SUBJECT: Forwards minutes of 830201-03 meetings w/Mechanical Engineering Branch to respond to questions transmitted in 821222 ltr. Responses committing to FSAR change will be incorporated into future amend.

SERIAL: LAP-83-63

SHEARON HARRIS NUCLEAR POWER PLANT
UNIT NOS. 1 AND 2
DOCKET NOS. 50-400 AND 50-401
MECHANICAL ENGINEERING BRANCH
FEBRUARY 1 - 3, 1983 MEETING MINUTES

Q 210.5

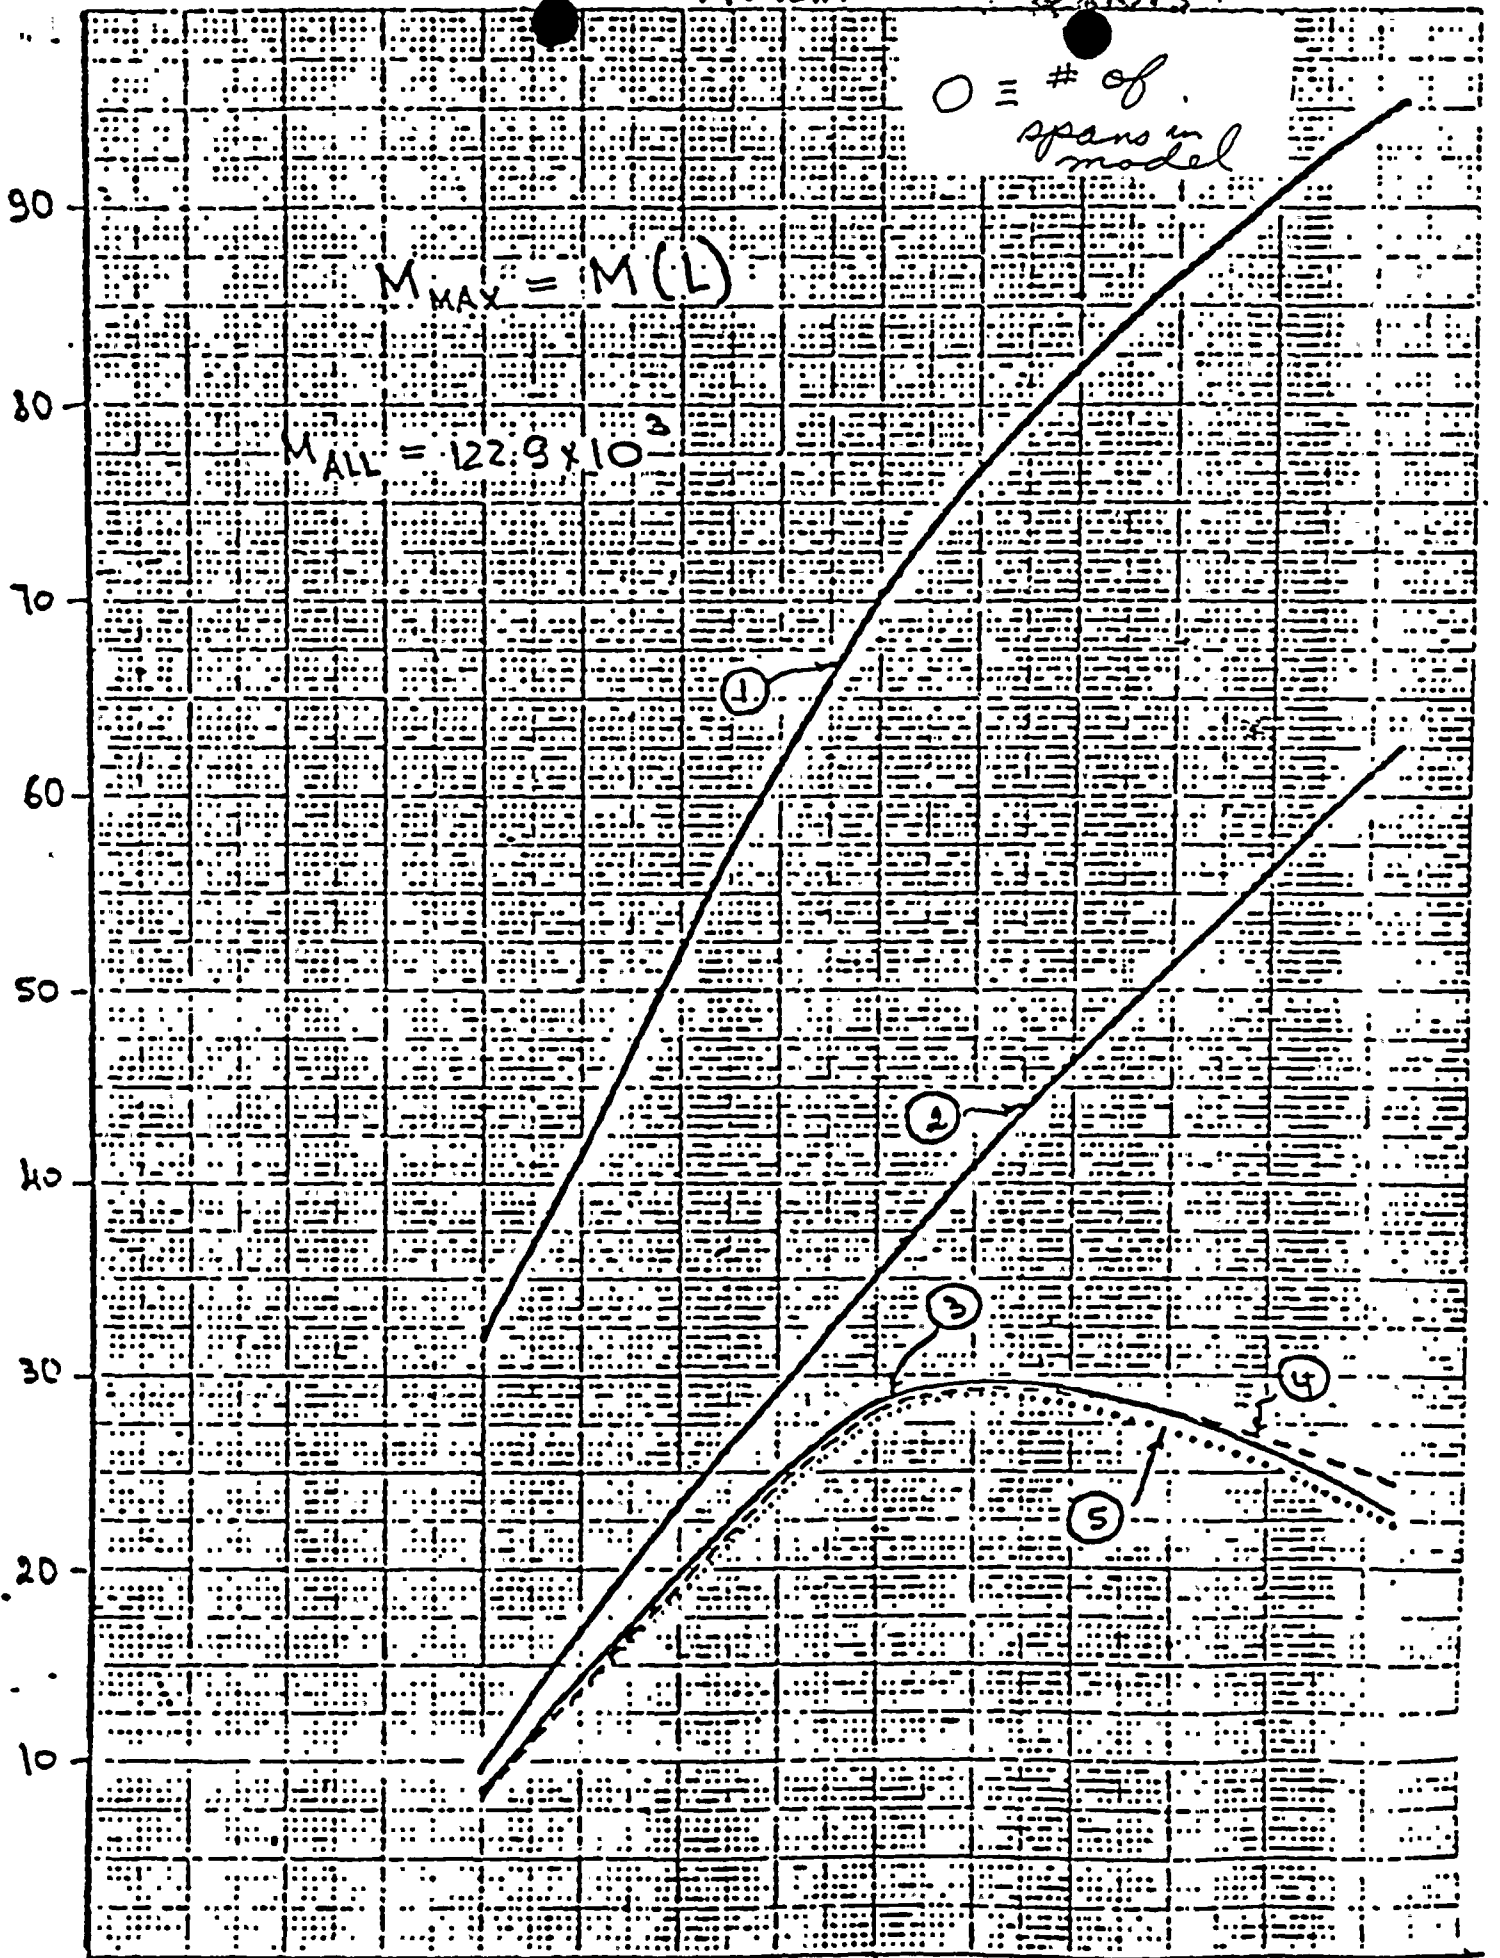
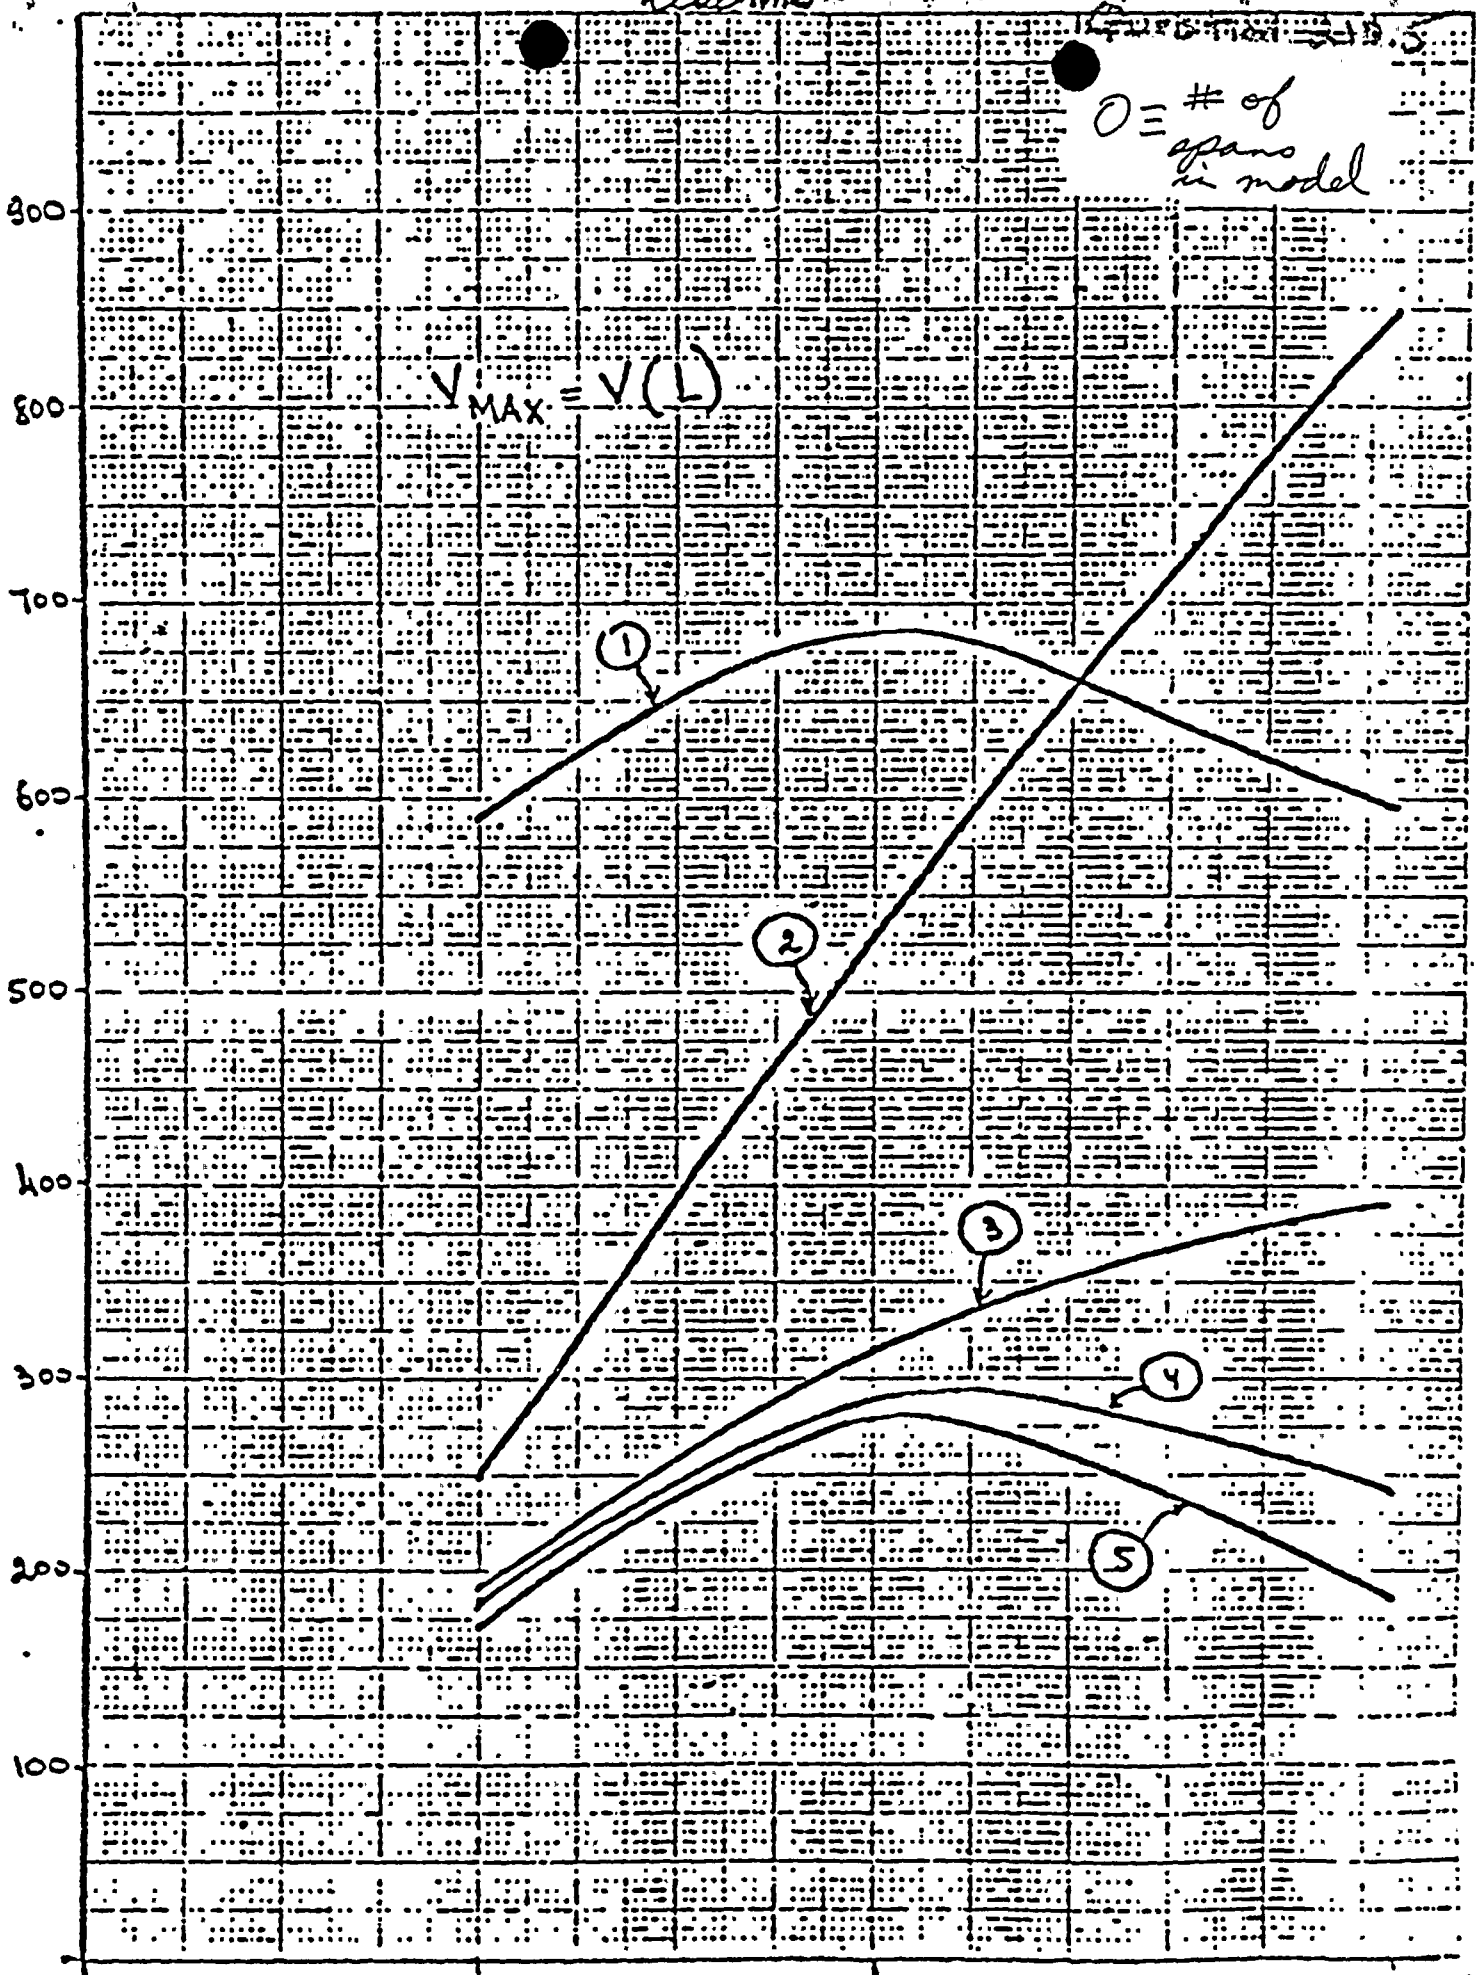
The criteria you have used for the effects of jet impingement forces is intended for postulating the effects of unrestrained whipping pipe. Provide justification for applying this criteria to the effects of jet impingement.

moment (see attached example curves which demonstrate the conservatism of employing a single span model from the moment and reaction force standpoint as well as for the span lengths in question. The generic capability of the restraints to accept the resulting loads is not as easily demonstrated as the integrity and functionality of the pipe, since restraint design varies quite widely.
